NL-20-033

April 28, 2020

Subject: Technical Specifications Proposed Change – Permanently Defueled Technical Specifications

Indian Point Nuclear Generating Station Unit No. 3 NRC Docket No. 50-286 Renewed Facility Operating License No. DPR-64

Fuel Assembly Classification for Storage in the Spent Fuel Pit

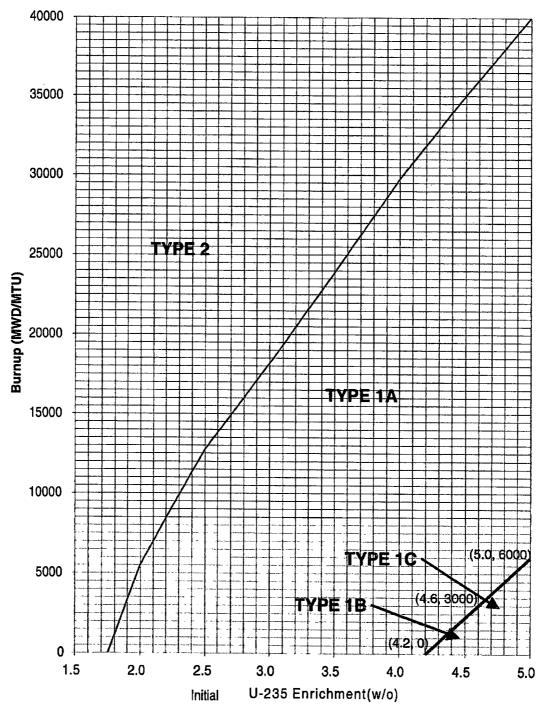
r	
TS 3.7.16, Spent Fuel Assembly Storage	Technical Specification 3.7.16, including Figure 3.7.16-1, is retained in the PDTS. The title of TS Section 3.7 is administratively changed from addressing "plant systems" to addressing "spent fuel pit requirements" to comport with the remaining PDTS Section 3.7 LCOs. In addition, the NOTE in Required Action A.1 (LCO 3.0.3 is not applicable) is proposed to be deleted to conform to the deletion of TS LCO 3.0.3 as previously proposed.
TS 3.7.17, Secondary Specific Activity	Technical Specification 3.7.17 is proposed for deletion. Technical Specification 3.7.17 is applicable in MODES 1 through 4.
	After the certifications required by 10 CFR 50.82(a)(1) are docketed for IP3, the 10 CFR Part 50 license will no longer authorize operation of the reactor or placement or retention of fuel in the reactor vessel in accordance with 10 CFR 50.82(a)(2). Thus, operation in MODES 1 through 4 will no longer occur. As a result, this TS will not be applicable in a permanently defueled condition.

Racks, Regions and Indexing

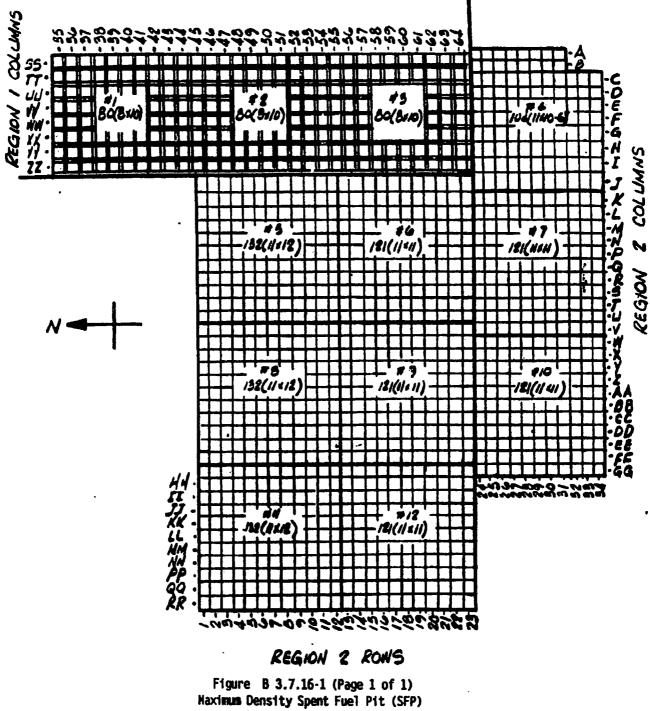
BACKGROUND In the Maximum Density Rack (MDR) design, the spent fuel pit (SFP) is divided into two separate and distinct regions. The layout of the IP3 MDR is shown in Figure B 3.7.16-1, IP3 Maximum Density Spent Fuel Pit Racks, Regions and Indexing. As shown in Figure B 3.7.16-1, Region 1 (i.e., Columns SS-ZZ, Rows 35-64) includes 240 storage positions and Region 2 (i.e., Columns A-RR, Rows 1-34) includes 1105 storage positions. Region 1 is analyzed for storage of high-enrichment and lowburnup fuel. Region 2 is analyzed for storage of fuel with either higher burnup or lower enrichment. Each region has been separately analyzed for close packed storage when all cells in that region contain fuel of the highest reactivity that is allowed by this LCO. This analysis is the basis for the restrictions on fuel storage locations established by this LCO.
